Proposal based on ACSF-03-16

Proposal for amendments to Regulation No. 79 to include ACSF > 10 km/h

French comments: The aim of the R79 is to approve the steering function and the systems considered as lateral support. Thus in this viewpoint the current regulation should only include provisions relative to the lateral movement independently of any other automated driver support. If the involved systems are combined with these other automated systems, for example systems acting on speed, on brakes or using rearview vision, these systems must be type approved as combined systems fulfilling the requirements of new independent regulations based on each use case.

3.1.2. Functionality Test 2 (FU2)

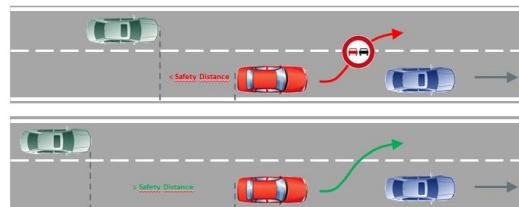
New test t.b.d. by OICA

Nevertheless the red vehicle should not perform the lane change manoeuvre, because of the short safety distance to the green vehicle.
